Access Compliance Report

Public Rights-of-Way

(Pedestrian Signals)

Intersection ID: N/A	Main Street:	Cross Street: N/A	Location: N/A
ADA ID: E5FFFF894E29	Signal Type: Two Push Buttons-Non APS	Overall Compliance: No	Severity Score: BTN 1:N/A BTN 2: N/A No BTN: N/A
Codes/Mitigation Info/Possible Solution		Field Measurements/Component Compliance

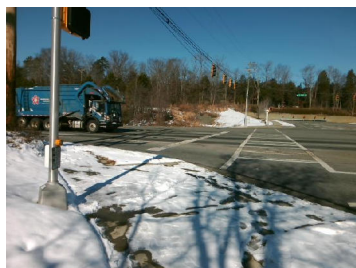
Possible Solutions: Replace Signal Push Button With APS Button on New Post. Remove & Relocate Sign.

PROW/ADA: TMUTCD 4e.08, R404.2, R404.3, R406.2, R404.7.2, R104.2, R209.1
